RE: Request for Septic Easement Variance
15305 Doe Hill Court
Woodbine, MD 21797

THE PAIR RESIDENCE
SITE PLAN - REQUEST FOR SEPTIC EASEMENT VARIANCE AND REVISIONS
 1" = 50'
 NOVEMBER 17, 2008

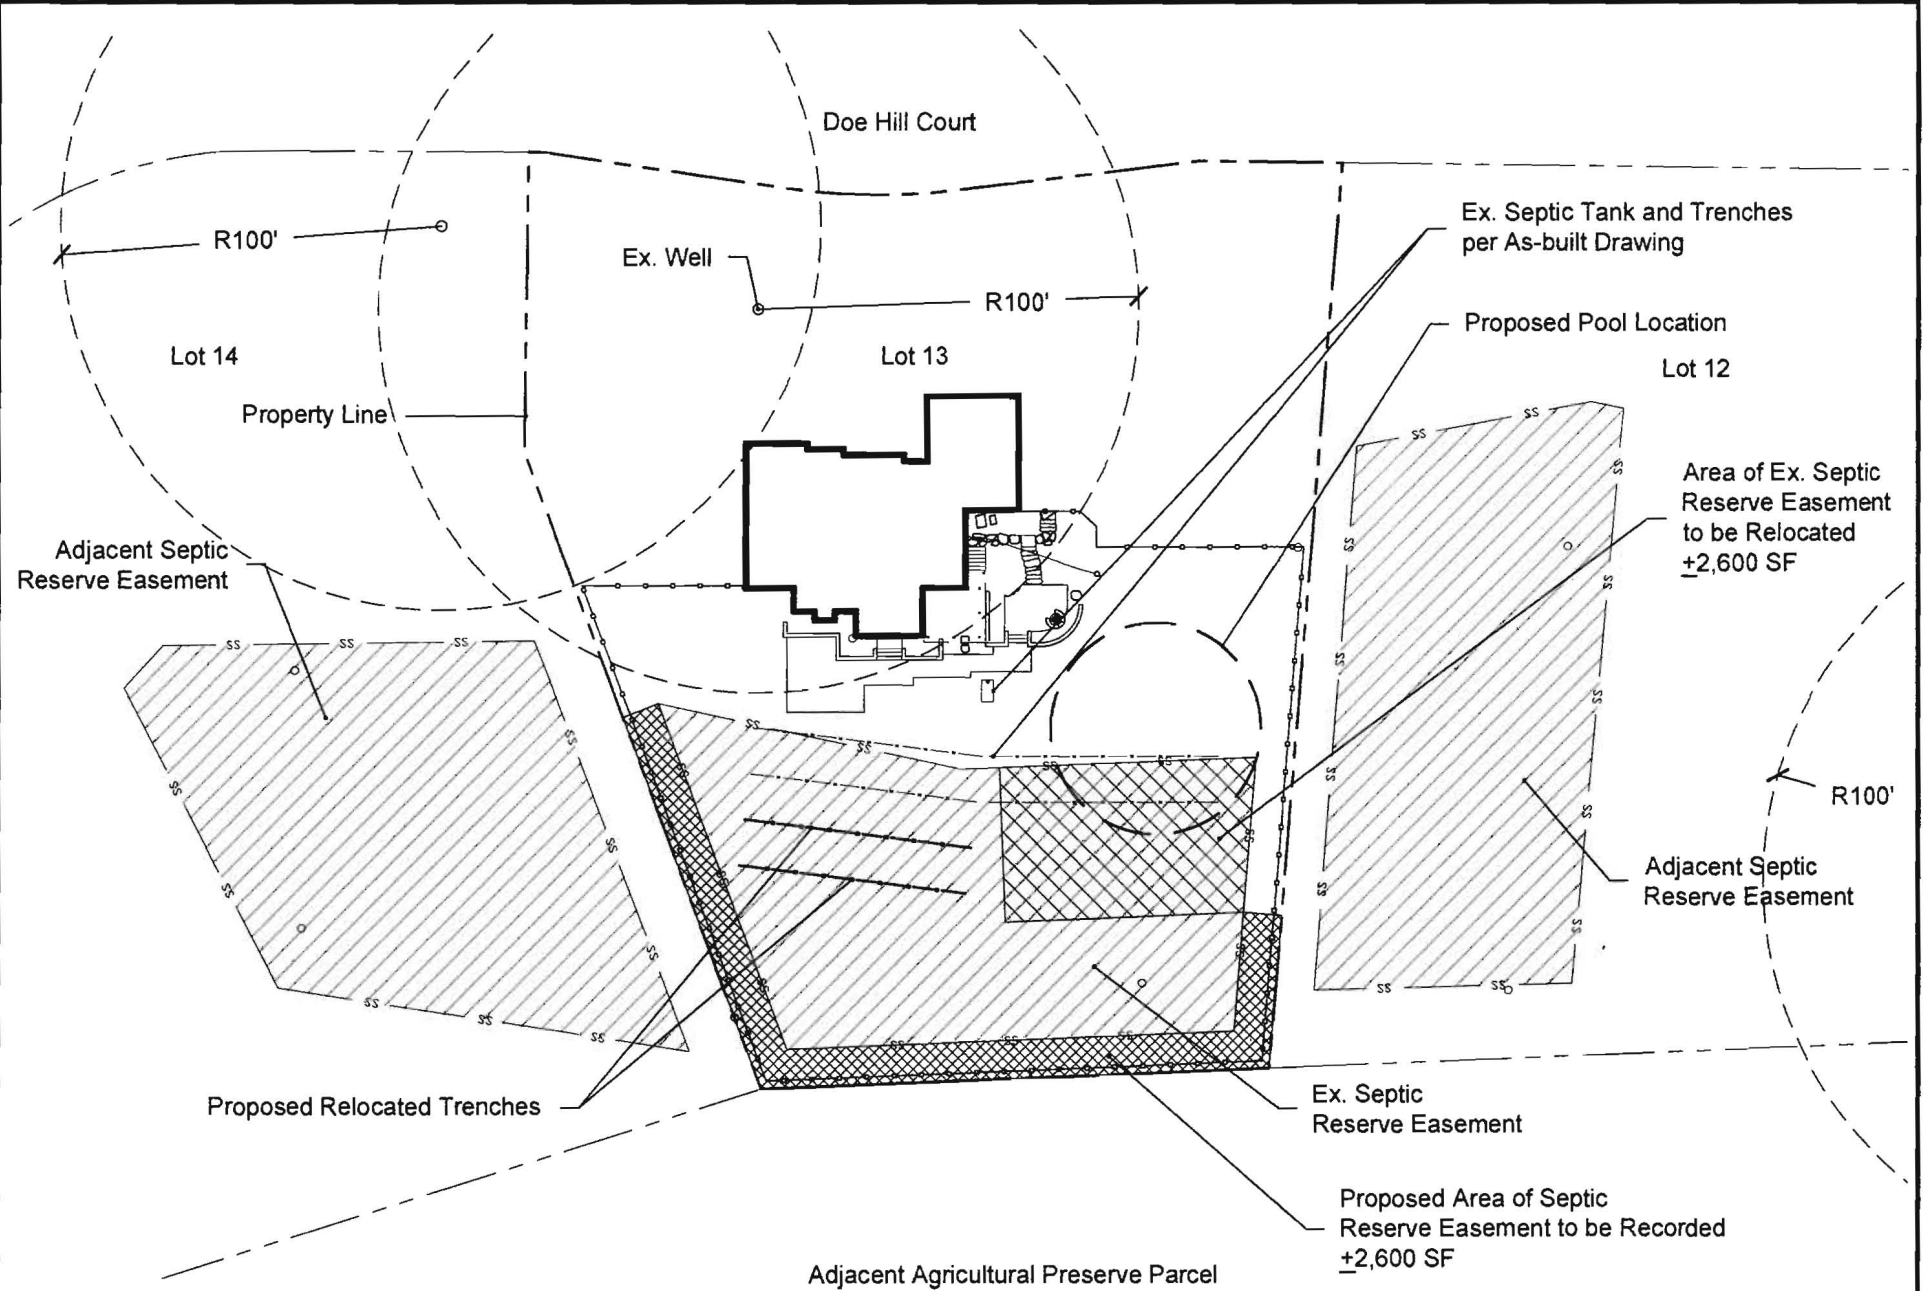
- ① Need pool foot print ✓
- ② Need perc cert ✓
- ③ IS OK if expose d-box
to confirm exact
location ✓
- ④ Plan must show
trenches for 2
systems ✓
- ⑤ 5 ft to prep line
for lots w/ platted ✓
10K
